Subject: Application for Permit Modification to the Section 404 Individual Permit and Section 401 Water Quality Certification for Construction of extension of NC 43 from south of NC 55 to north of US 17. Craven County. State Project No. 6.804857. TIP No. R-4463. Debit \$570 from WBS 35601.1.1.

The purpose of this letter is to request a modification to the US Army Corps of Engineers (USACE) Section 404 Individual Permit and NC Division of Water Quality (NCDWQ) Section 401 Water Quality Certification. The North Carolina Department of Transportation (NCDOT) is currently constructing the extension of NC 43 from NC 55 to US 17. The project, located west of New Bern in Craven County, is referred to as the NC 43 Connector (Bosch Boulevard) and is approximately 4.5 miles in length. A Section 404 Permit (Action ID 2007-02231-125) was issued on November 19, 2007 and Water Quality Certification issued (WQC No. 3673) on September 21, 2007. The project has been split into two sections, Section A and Section B. Section B has been let and construction has begun.

Summary of Changes

Table 1. Additional Permanent Jurisdictional Impacts for R-4463B

PROJECT REFERENCE NO. R-4463B	SHEET NO. 20
ROADWAY DESIGN ENGINEER 	HYDRAULICS ENGINEER

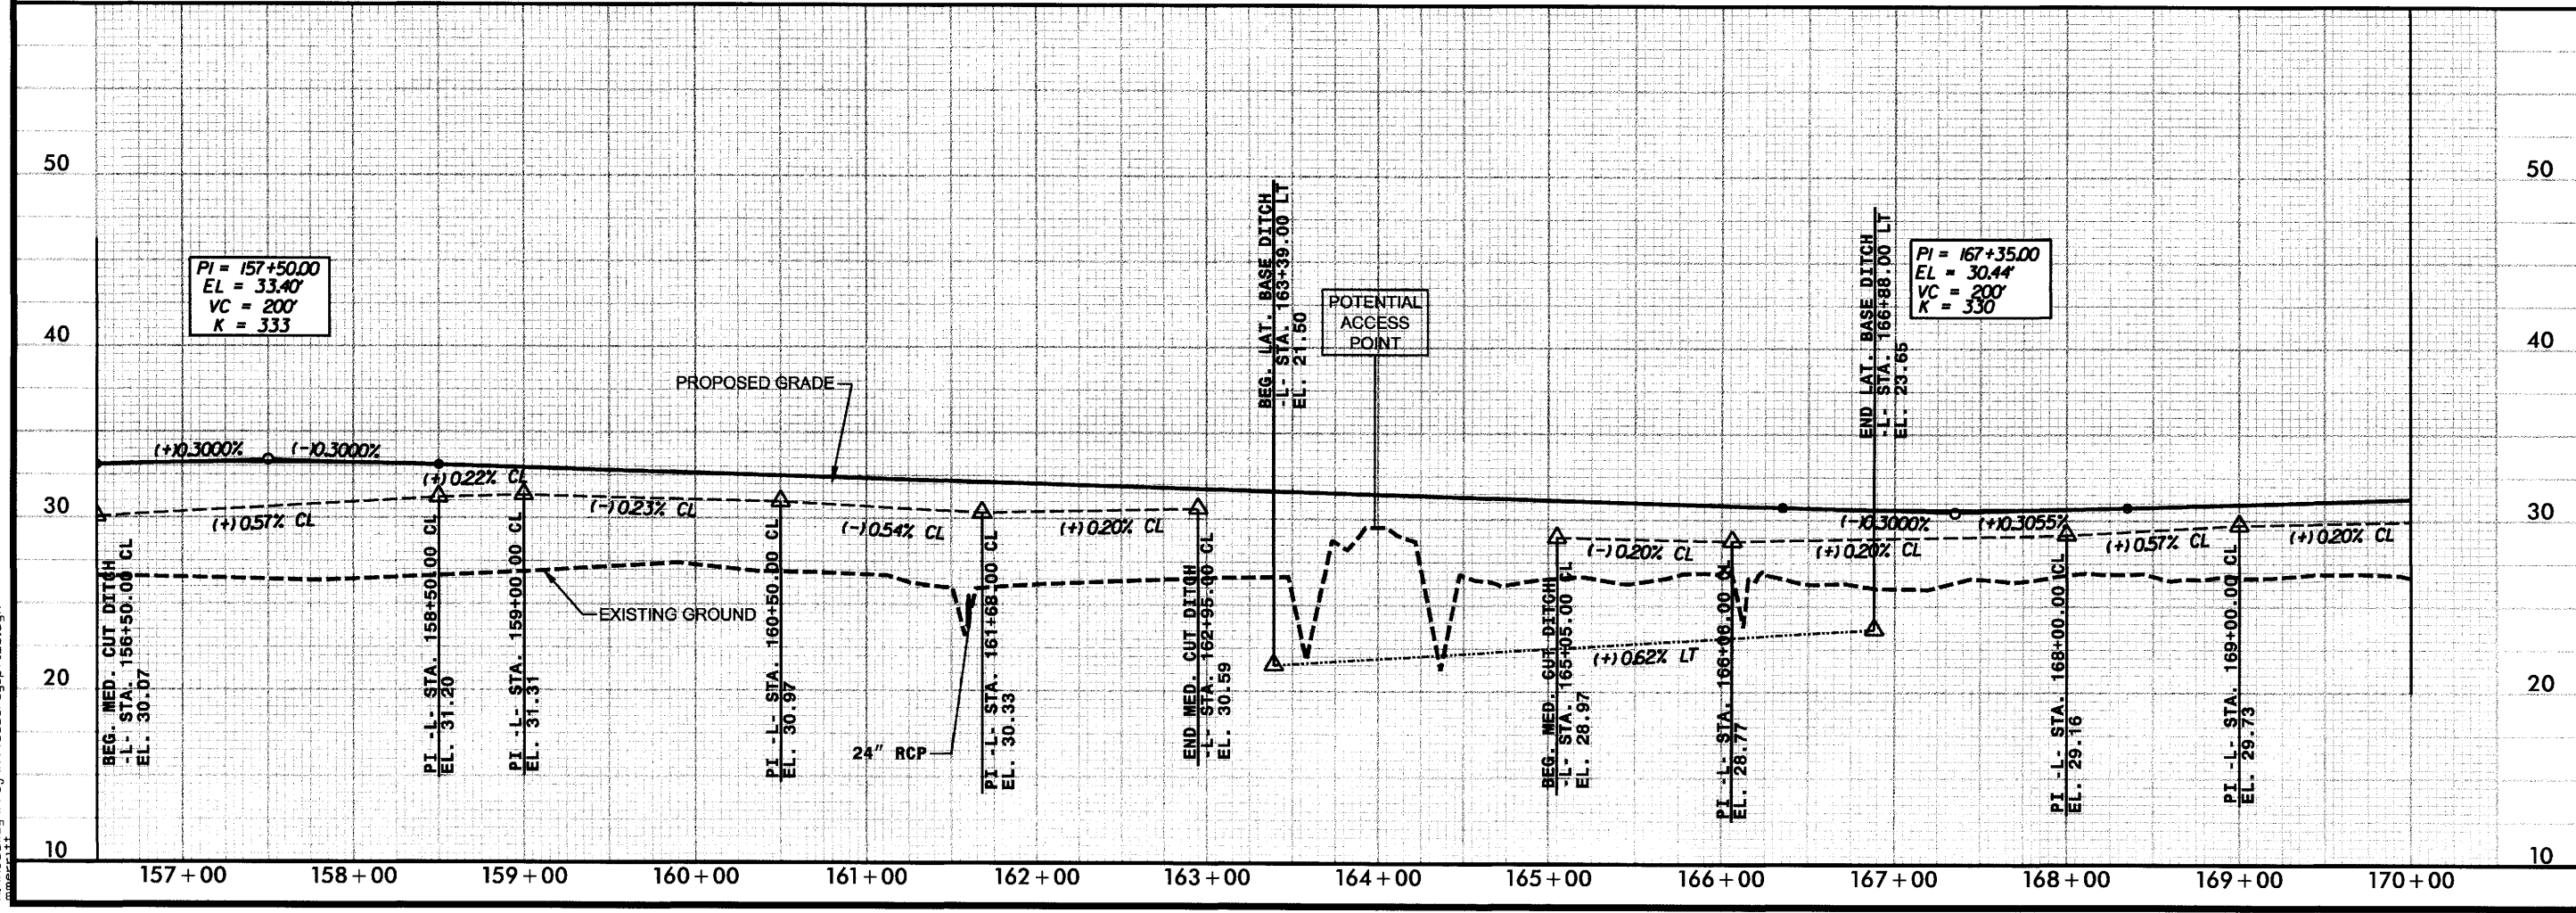
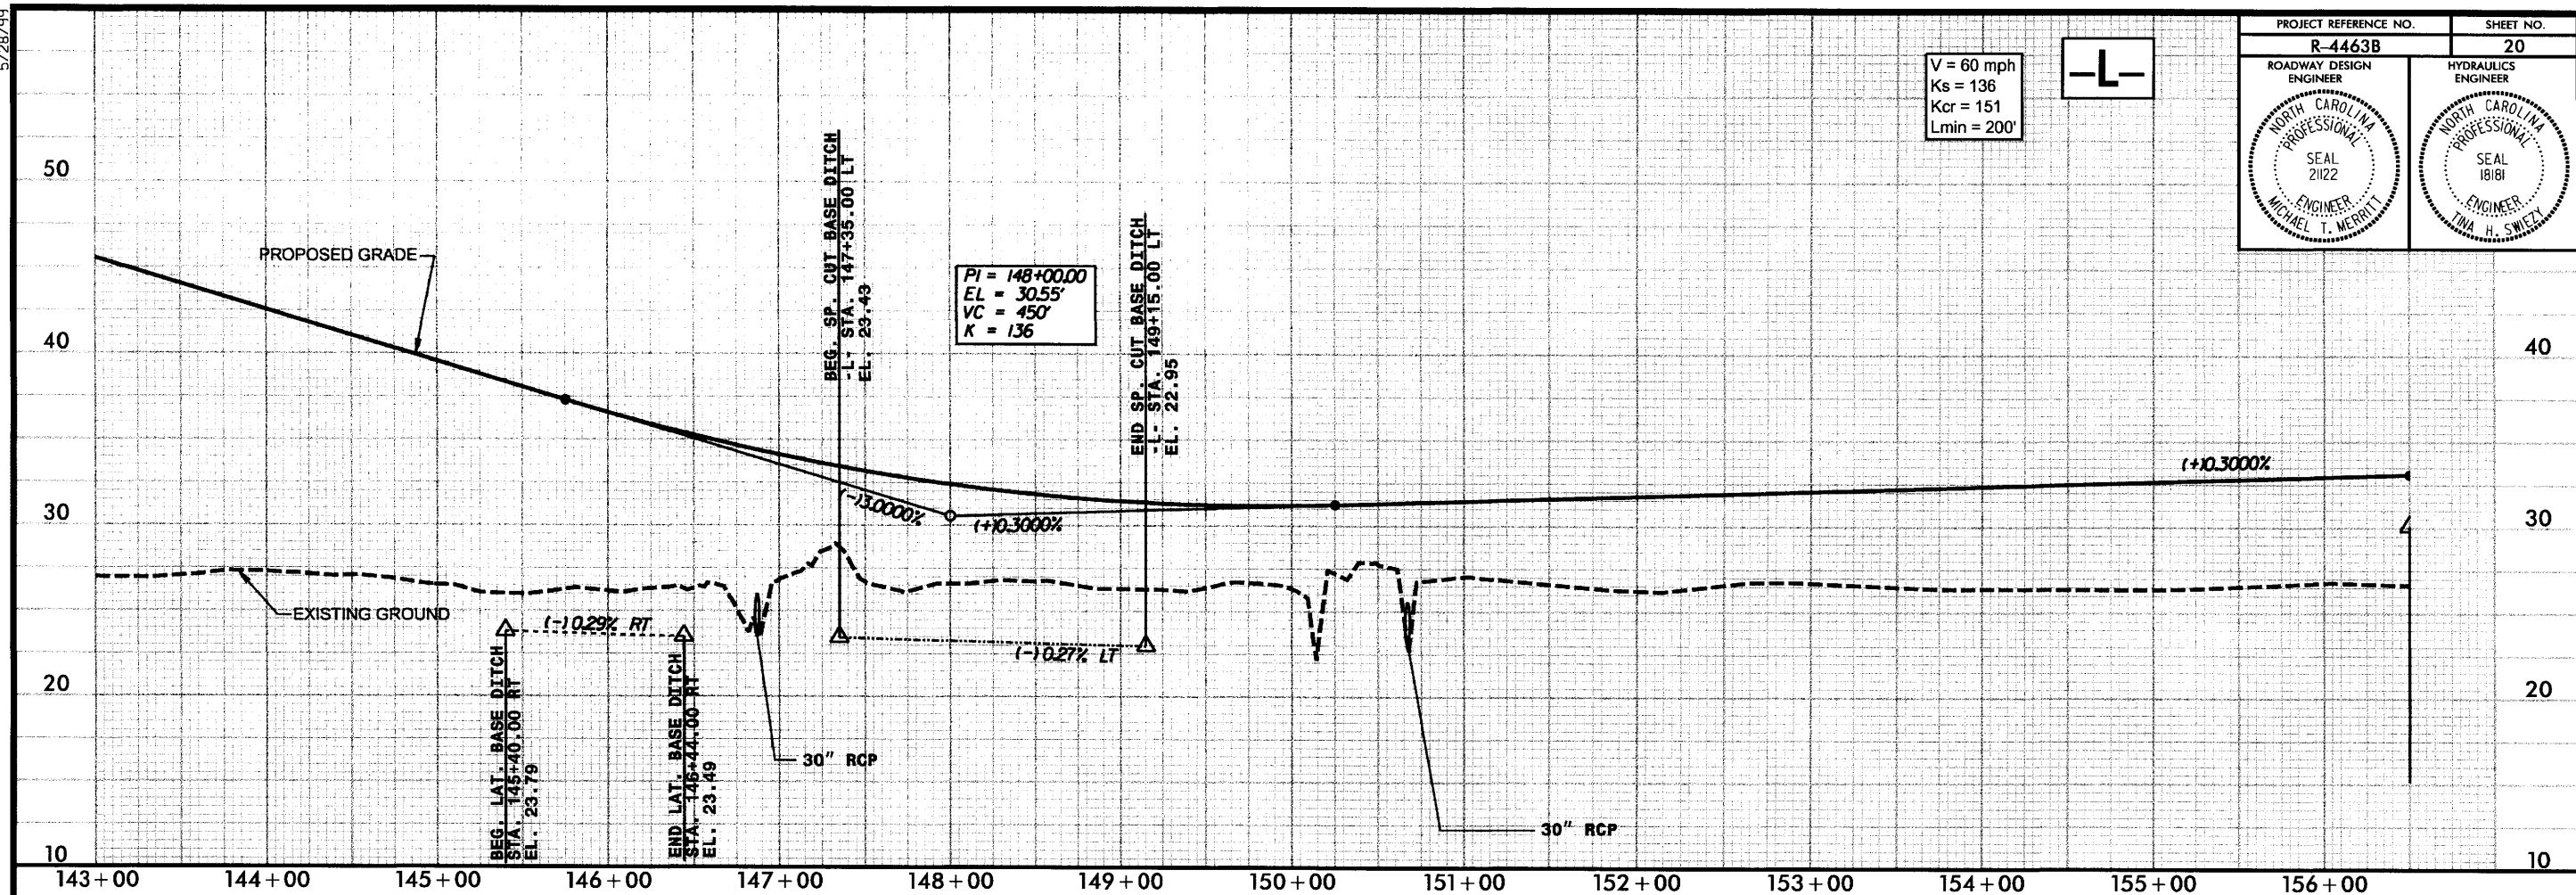
Construction Revision #2, Date: ----- Proposed grade revised from -L- Sta. 171+50 to 205+73.15 for new horizontal and vertical clearance criteria for the railroad.

PROJECT REFERENCE NO. R-4463B		SHEET NO. 22	
ROADWAY DESIGN ENGINEER		HYDRAULICS ENGINEER

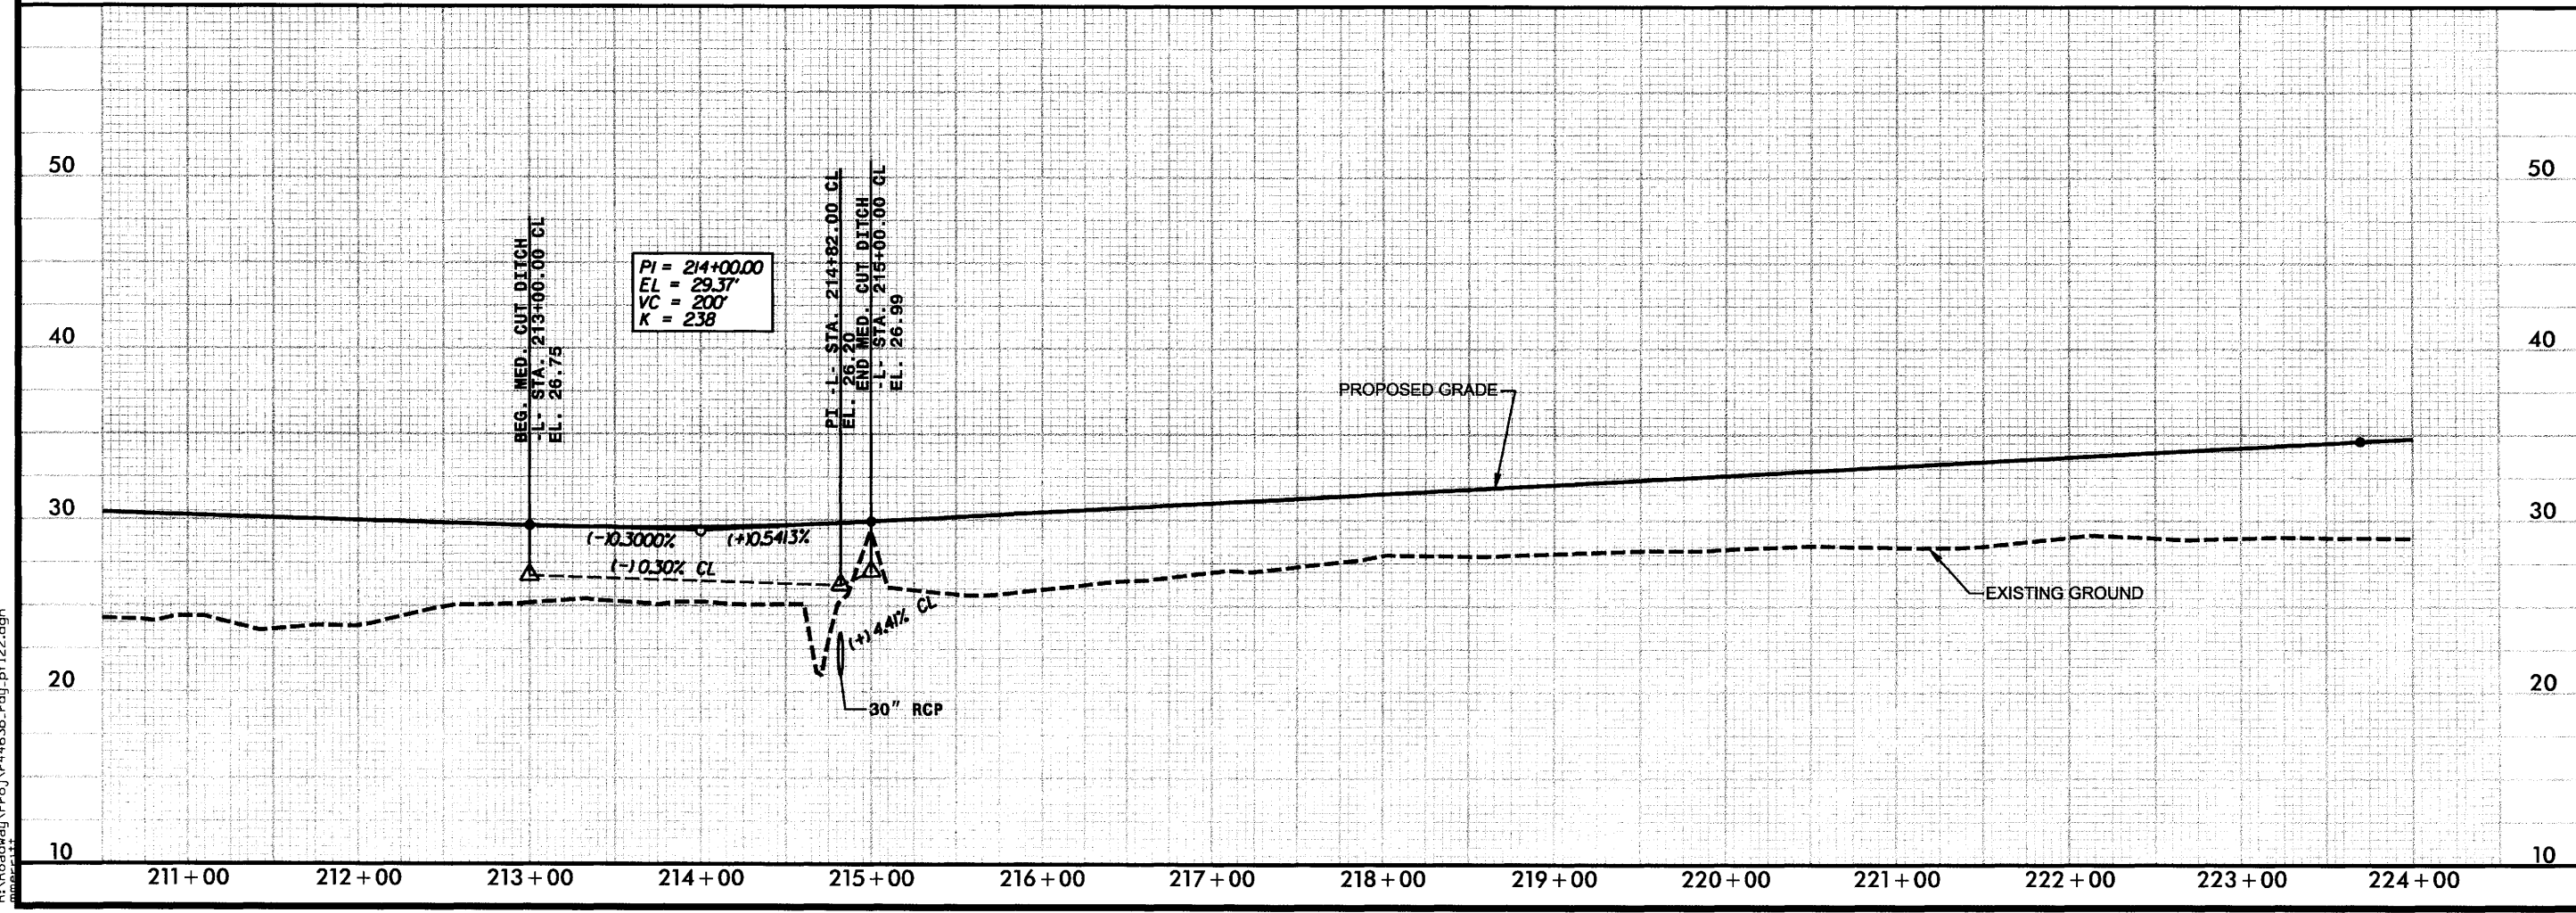
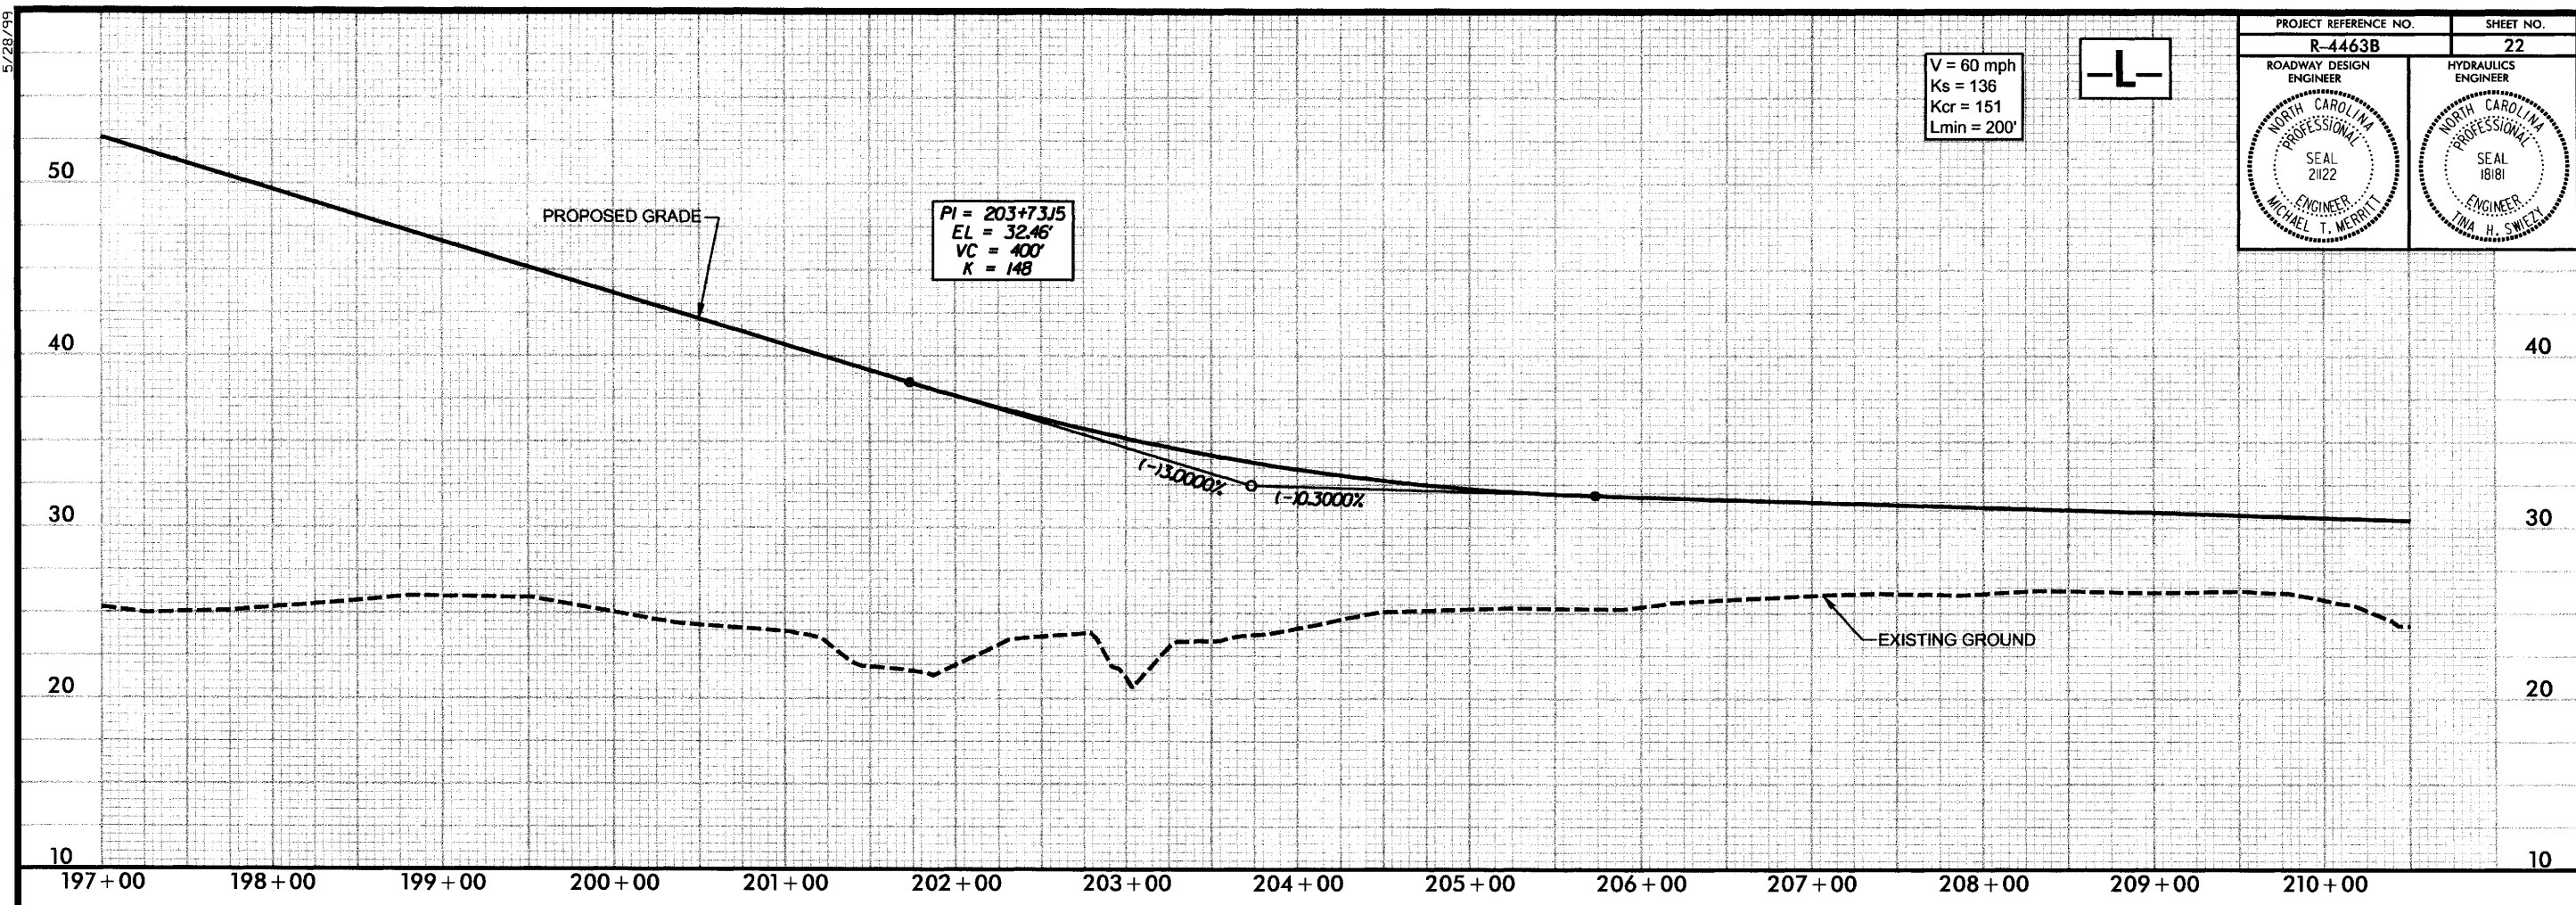
Construction Revision *2, Date: 5/28/99 Proposed grade revised from -L- Sta. 171+50 to 205+73.15 for new horizontal and vertical clearance criteria for the railroad.
